ALERT SERVICE BULLETIN

ASB No. AA-07109

Revision A

High Landing Gear Aft Crosstubes

FIGURE 1 – CLEAR COAT AND INSPECTION AREA POST REVISION A

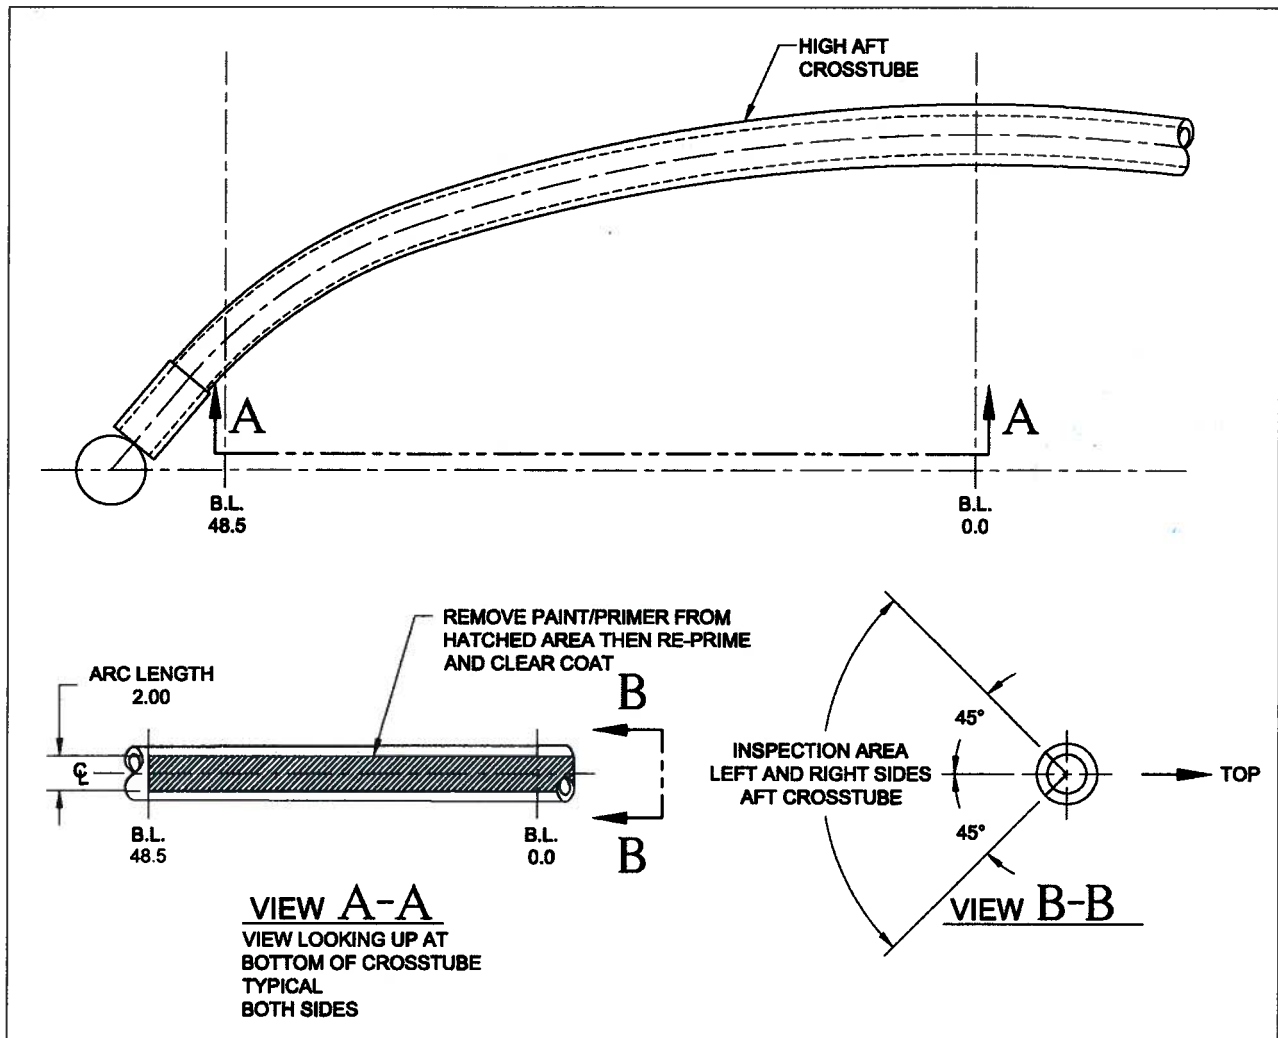
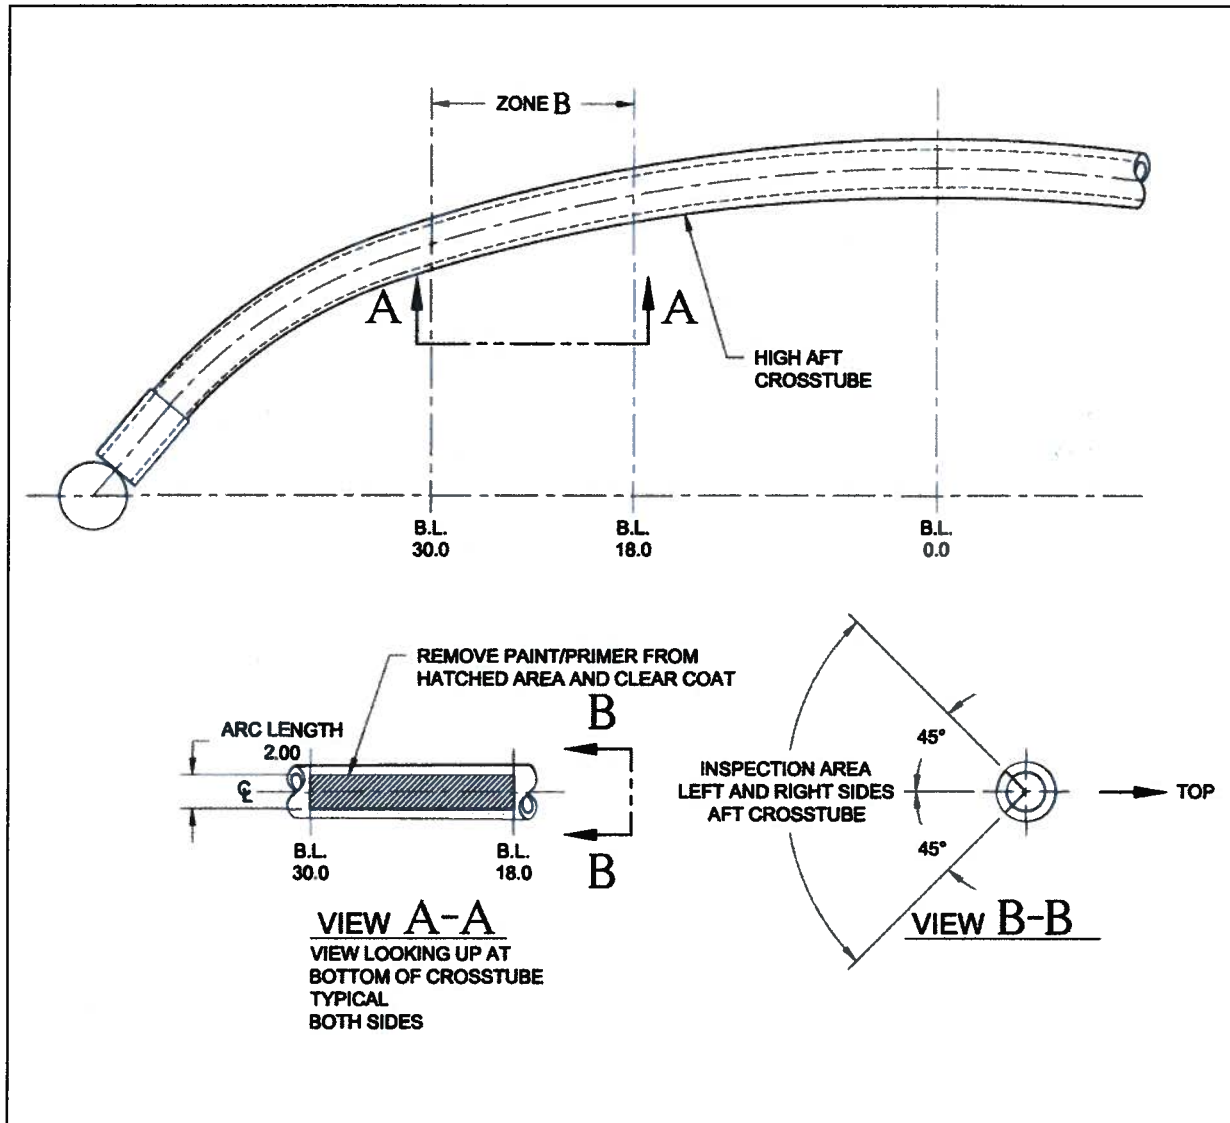
Expand the inspection area.

Revision A – Crosstubes with takeoff/landings greater than 12,500 that do not have the expanded inspection area shown in Figure 1 must accomplish Part B within 50 hours or 250 takeoff/landings from receipt of Revision A of this bulletin.

Serial number AA-1603 and subsequent are manufactured with the expanded inspection area of Revision A primed and clear-coated.

Serial number AA-1603 and subsequent are manufactured with the expanded window of Revision A primed and clear-coated.

1. Prepare crosstube inspection area by chemically removing crosstube paint and primer from an area 2.0 ± 0.25 inches wide extending between RBL 48.5 and LBL 48.5 at the center-bottom surface of the crosstube (see Figure 1).

FIGURE 4 – PAINT REMOVAL AREA POST REVISION A

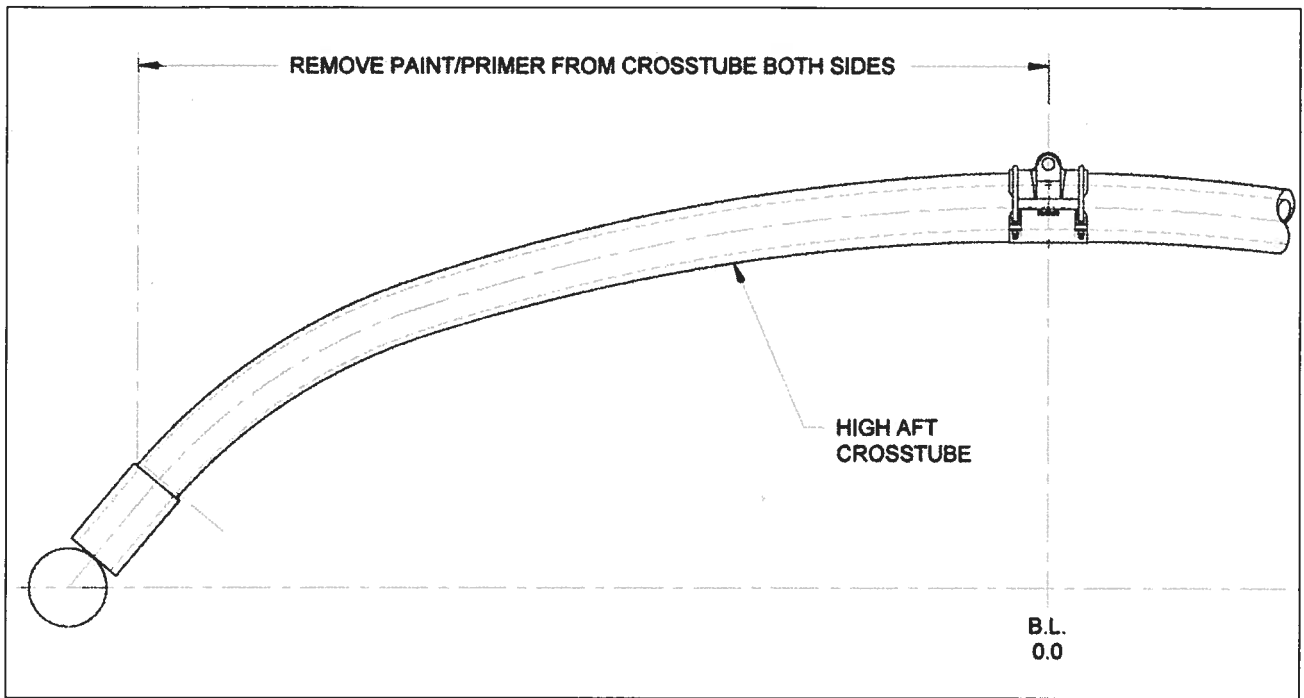
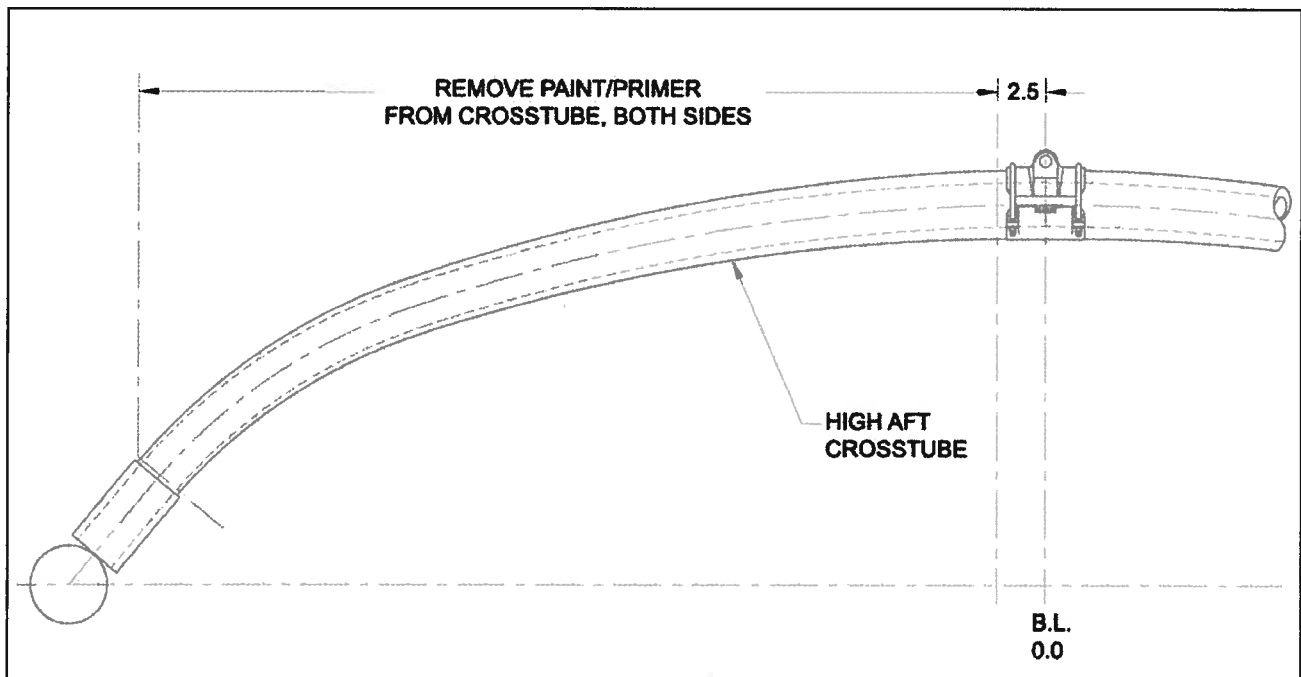
Incorporate the expanded inspection area per Revision A during overhaul.

2. Prepare crosstube by chemically removing crosstube paint and primer outboard of the Upper Center Support to top of saddles. See Figure 4.
